SUBJECT: JAMES A FITZPATRICK NUCLEAR POWER PLANT- STAFF ASSESSMENT OF INFORMATION PROVIDED PURSUANT TO TITLE 10 OF THE *CODE OF FEDERAL REGULATIONS* PART 50, SECTION 50.54(f), SEISMIC HAZARD REEVALUATIONS FOR RECOMMENDATION 2.1 OF THE NEAR-TERM TASK FORCE REVIEW OF INSIGHTS FROM THE FUKUSHIMA DAI-ICHI ACCIDENT (CAC NO. MF3725)

STAFF ASSESSMENT BY THE OFFICE OF NUCLEAR REACTOR REGULATION

RELATED TO SEISMIC HAZARD AND SCREENING REPORT

JAMES A. FITZPATRICK NUCLEAR POWER PLANT

Figure 3.3-1 Plot of Staff's and Licensee's Base Case Shear-Wave Velocity Profiles for the JAF site

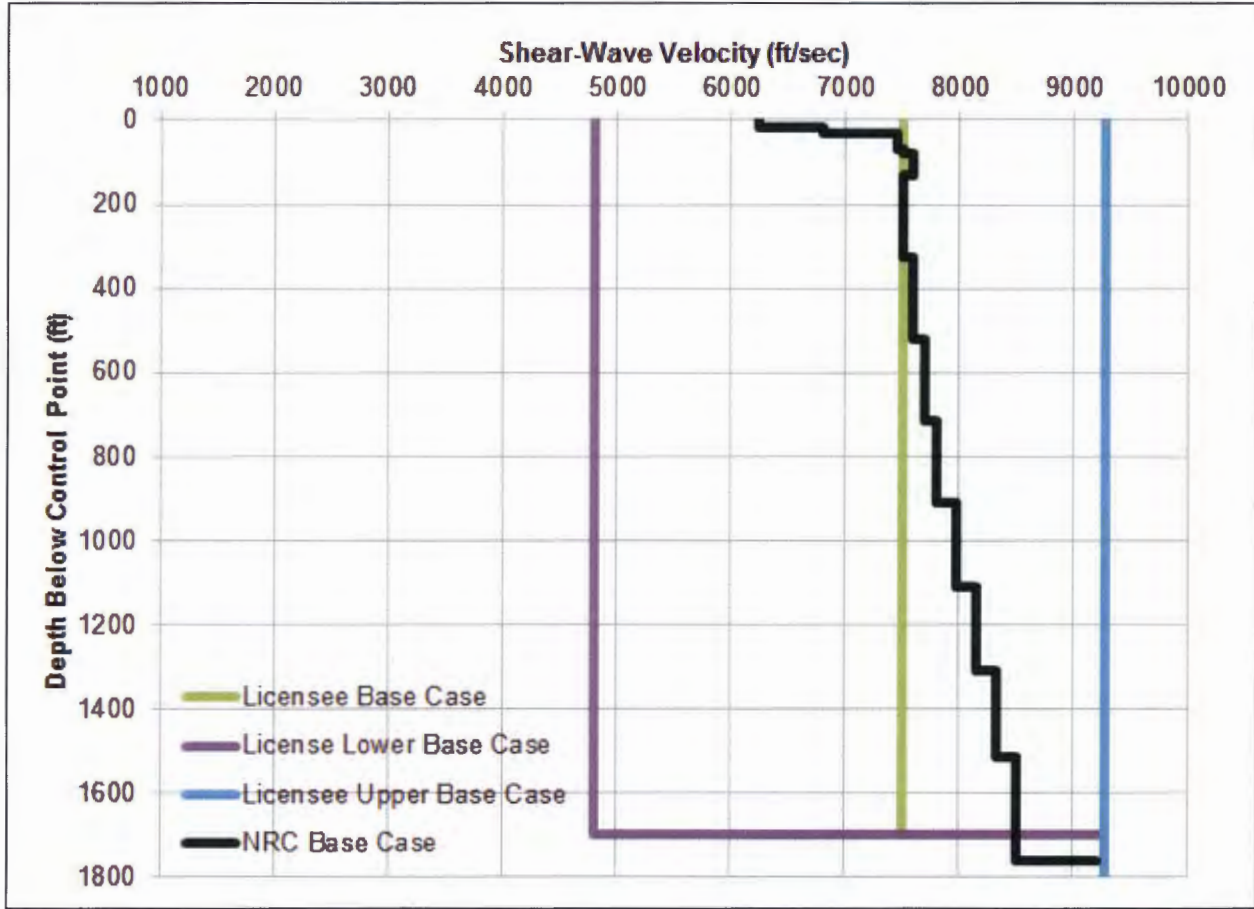
To characterize subsurface geology, the licensee developed three site base case profiles at the JAF site. The middle, or best estimate, profile was developed by taking the mean of the shear-wave velocity measurements for the Oswego Sandstone ( $V_s = 7,500$  ft/sec or 2,286 m/sec) to a depth of 1,700 ft (518 m) from the control point to hard reference rock. The licensee developed the upper and lower base case profiles using a natural log standard deviation of 0.35. Table 2.3.2-1 and Figure 2.3.2-1 of the SHSR provide the licensee's shear-wave velocity profile for each of the three base cases. Figure 3.3-1 of this assessment shows the licensee's three shear-wave velocity base case profiles.

Because abundant geophysical measurements were made at the proposed NMP3 site, which is located less than one mile (1.6 km) from the JAF site, and the sub-surface stratigraphy between the two sites appears to be relatively uniform, the NRC staff used the shear wave velocities measured beneath NMP3 for its site response confirmatory analysis. In addition, because these shear wave velocities for the proposed NMP3 site were measured using modern methods and analyses, the NRC staff used only a single shear wave velocity profile rather than the three profiles developed by the licensee for its site response analysis. To capture the uncertainty in the depth to reference or base rock, the NRC staff randomized the total profile thickness of 1,700 ft (518 m) value by  $\pm 150$  ft [ $\pm 46$  m]. Figure 3.3.-1 of this assessment shows the NRC staff velocity profile compared to the base case profiles developed by the licensee. As shown in Figure 3.3-1, the licensee's three base case profiles encompass a much larger range of shear

wave velocities than the range of velocities reported in the proposed NMP3 SAR (UniStar, 2009).

Figure 3.3-3 Plot Comparing the Staff's and the Licensee's Mean Control Point Hazard Curves at a Variety of Frequencies for the JAF site

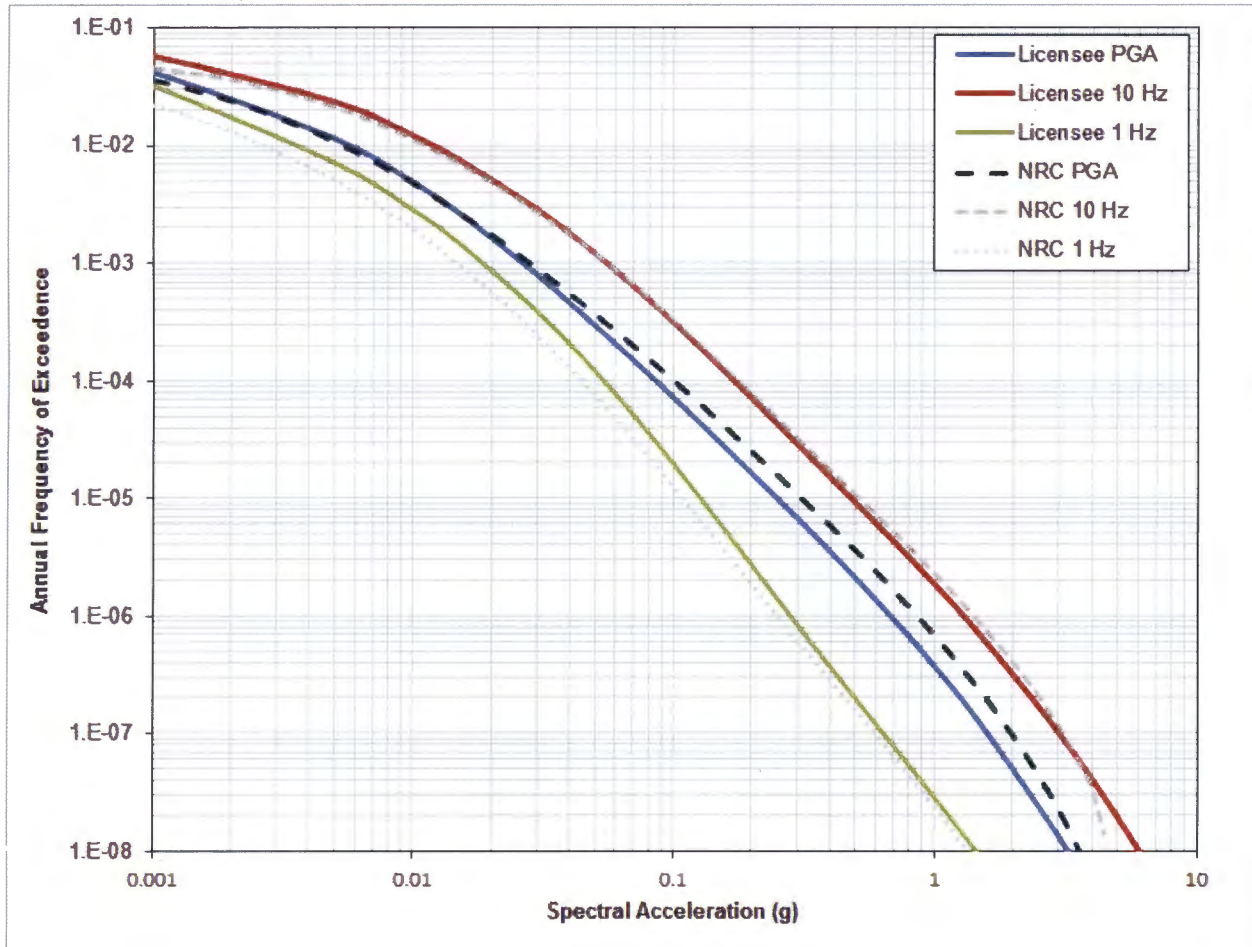
Overall the licensee's approach to modeling the subsurface rock properties and their uncertainty results in lower site amplification factors relative to the staff's results, particularly at high frequencies. As shown in Figure 3.3-3 of this assessment, these differences in the site response analysis have a minor impact on the 1 and 10 Hz control point seismic hazard curves; however, the NRC staff's confirmatory PGA or 100 Hz hazard curve is somewhat higher than the licensee's PGA hazard curve. Appendix B of the SPID provides guidance for performing site response analyses, including capturing the uncertainty for sites with less subsurface data; however, the guidance is neither entirely prescriptive nor comprehensive. As such, various approaches in performing site response analyses, including the modeling of uncertainty, are acceptable for this application.

**Figure 3.4-1 Comparison of the Staff's GMRS with Licensee's GMRS and the SSE for the JAF site**

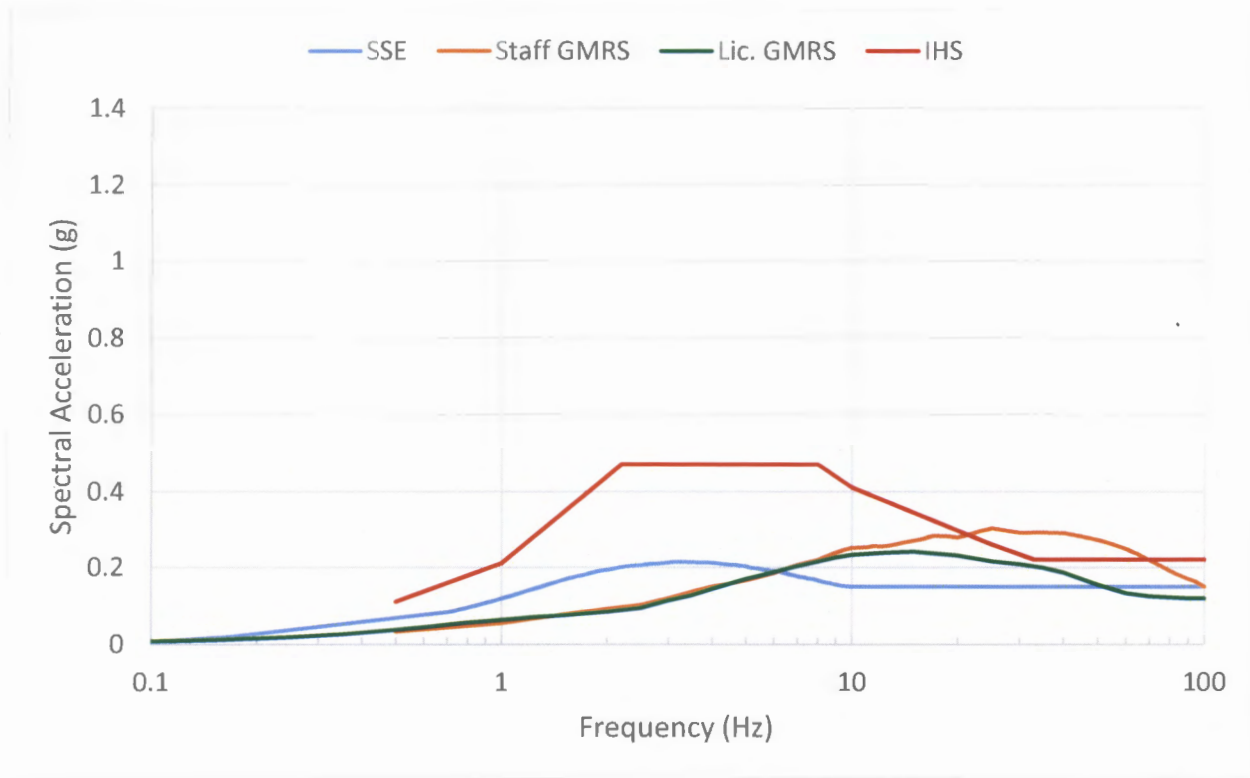
The NRC staff independently calculated the  $10^{-4}$  and  $10^{-5}$  UHRS using the results of its confirmatory PSHA and site response analyses, as described in Sections 3.2 and 3.3 of this staff assessment, respectively. Figure 3.4-1 of this assessment shows a comparison of the GMRS determined by the licensee to that determined by the NRC staff.

As shown in Figure 3.4-1, the licensee's GMRS shape is very similar to that calculated by the NRC staff at frequencies less than 10 Hz. However, the NRC staff's confirmatory GMRS is somewhat higher than the licensee's at frequencies above 10 Hz. As described above in Section 3.3, the NRC staff concludes that these minor differences over the higher frequency range are primarily due to the differences in the site response analyses performed by the licensee and the NRC staff.

The NRC staff confirms that the licensee used the present-day guidance and methodology outlined in RG 1.208 and the SPID to calculate the horizontal GMRS, as requested in the 50.54(f) letter. The NRC staff performed both a PSHA and site response confirmatory analysis and achieved results consistent with the licensee's horizontal GMRS. As such, the NRC staff concludes that the GMRS determined by the licensee adequately characterizes the reevaluated hazard for the JAF site. Therefore, this GMRS is suitable for use in subsequent evaluations and confirmations, as needed, for the response to the 50.54(f) letter.
